AR-TEX COMPOSITE LTD.

21 December 2021

Observations

Vertical bracing layout

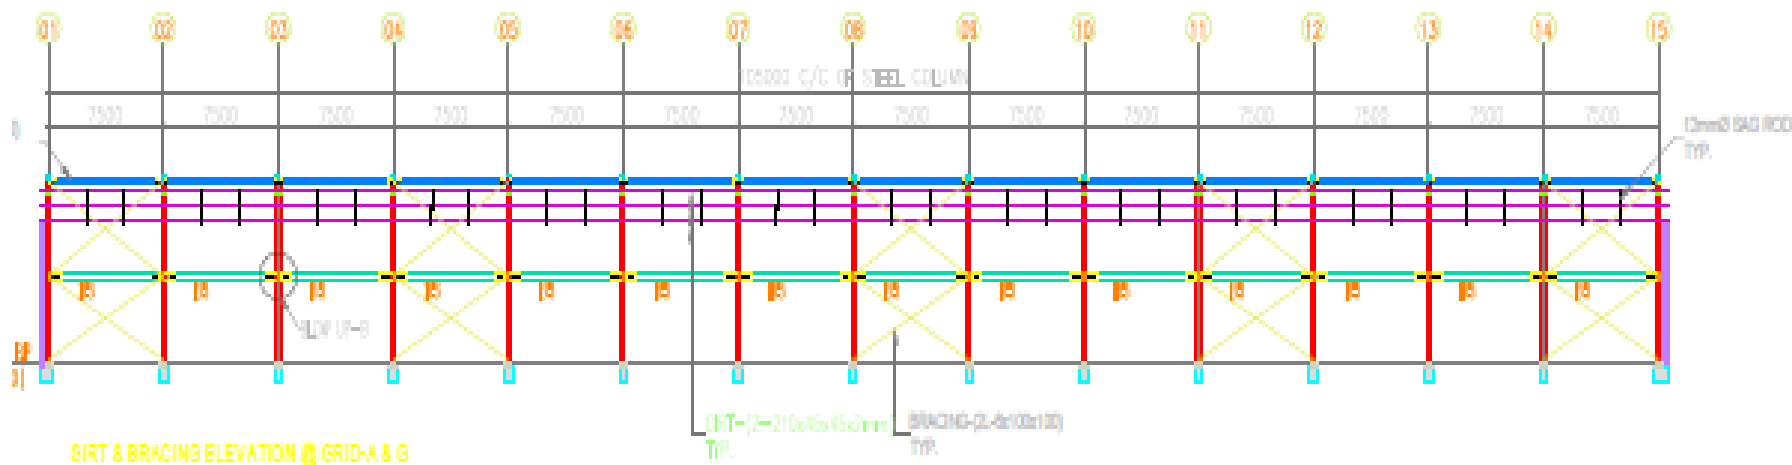
Absence of vertical bracings

No vertical bracing at wall

Vertical bracing layout shown in the provided drawing, but no vertical bracing observed on-site. Building engineer to check the bracing requirement and suggest remedial actions accordingly.

Pile foundation layout and schedule

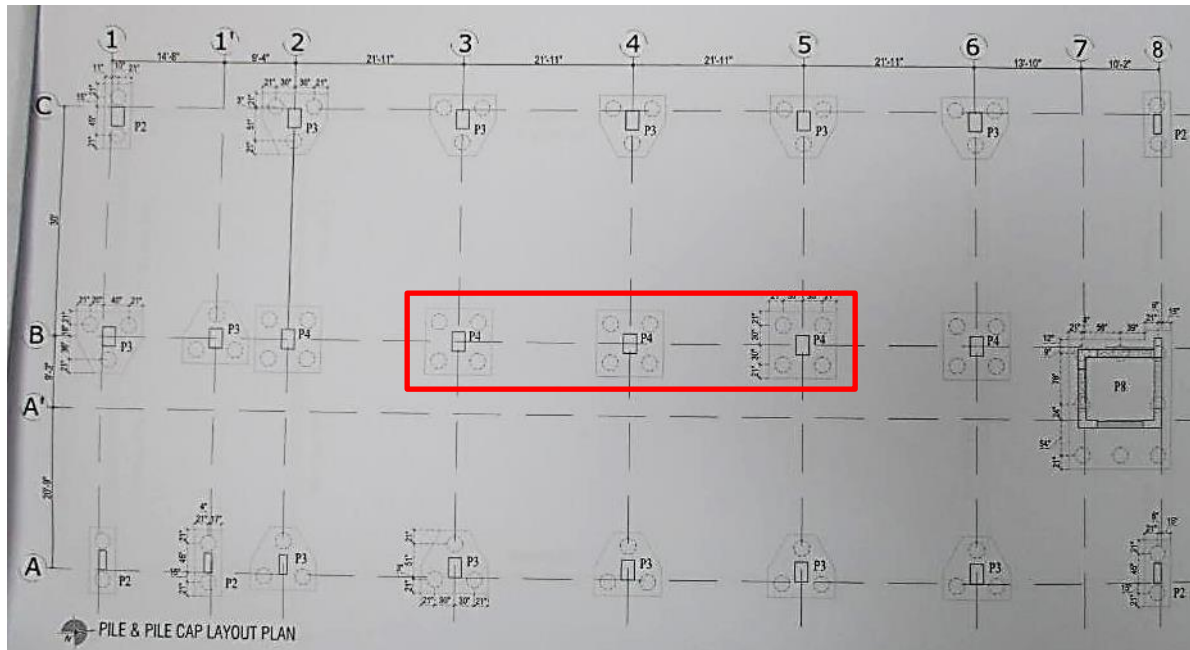
Foundation stress exceeds above normal design limit

Cursory calculation indicates that foundations are stressed above normal design limit considering typical floor live load 3 kPa, loads from UGWR approximate 18 kPa, ultimate single pile capacity from soil test report (3x70 ton= 2055 kN) and minimum concrete strength (16.3 MPa). The building engineer is required to check the design, loads, foundation stresses for the marked foundations based on in-situ material strength and suggest necessary remedial actions accordingly.
